PROJECT
**Caerleon Road
Dinas Powys**

TITLE
**Levels Strategy
Sheet 2 of 2**

DATE 25.01.17	DRAWN DJH
SCALE 1:250	CHECKED AM
DRAWING NUMBER 16022-103	REVISION B

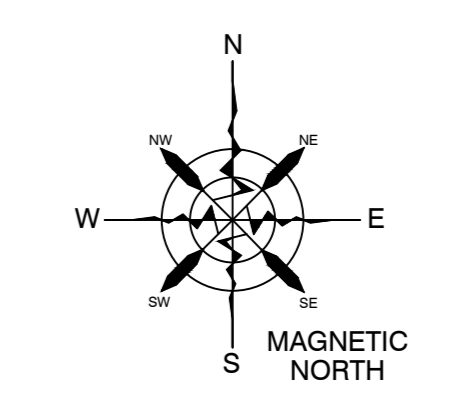
Further survey information required to site boundary to ascertain retention requirements and level differences

Further survey information required to site boundary to ascertain retention requirements and level differences

Further survey information required to site boundary to ascertain retention requirements and level differences
